River Quest Phase 3, KPB File 2024-013
 Edge Survey & Design LLC / Nash
 Location: Porter Rd., Brooklyn Ave. & Caden Cir.
 Kalifornsky Area

ITEM #6 - PRELIMINARY PLAT RIVER QUEST PHASE 3

KPB File No.	2024-013
Plat Committee Meeting:	February 26, 2024
Applicant / Owner:	Leland Corporation of Boise Idaho
Surveyor:	Mark Aimonetti and Jason Young / Edge Survey and Design LLC
General Location:	Porter Rd, Brooklyn Ave

STAFF REPORT

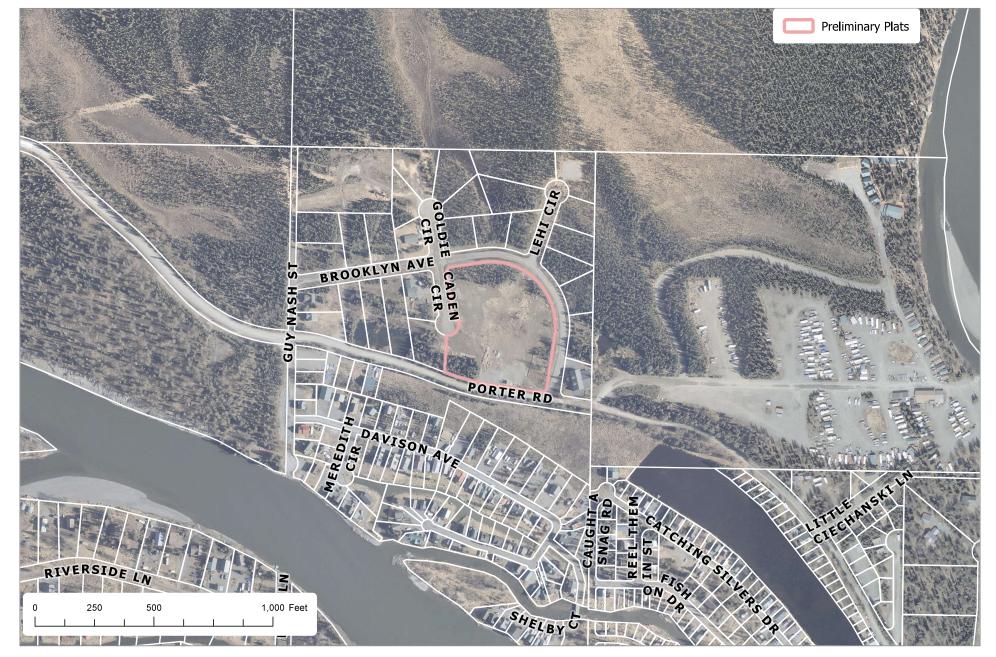
The terrain of the plat is flat with a low spot in the back of the lots. Wetlands are not identified on the plat though. The River Center review did identify plat as being in a FEMA FIRM flood hazard area and the proper flood hazard note is shown at plat note #11. Flood Zone A4 need to be added to plat note #11 as the River Center review indicated that zone to be included on the plat. Zone A4 should also be added to the drawing.

HEA has noted in their reply that plat note #7 does not affect this plat and can be removed. Their reply has also crossed out plat note #8, so it too can be removed. The comment is in the packet

- Add to legal description in title block, Block 2
- Correct spelling of Leland Corporation in both the title block and Certificate of Ownership and Dedication.
- Correct spelling of Boise in the address in both the title block and Certificate of Ownership and Dedication.
- D. A vicinity map, drawn to scale showing location of proposed subdivision, north arrow if different from plat orientation, township and range, section lines, roads, political boundaries, and prominent natural and manmade features, such as shorelines or streams;

Reduce scale and make area around site more readable.

- The borough will not enforce private covenants, easements, or deed restrictions per KPB 20.60.170.
- Plat note #5 needs the date corrected to July 10, 1997.
- Plat note #6 add an "s," to the end of Communication to match the certificate to plat.
- Plat note #11 needs to have the zone of A4 added to it per the River Center review.

Change member name to Robert Nash, to match the entity details as listed as the registered agent with the State of Alaska.
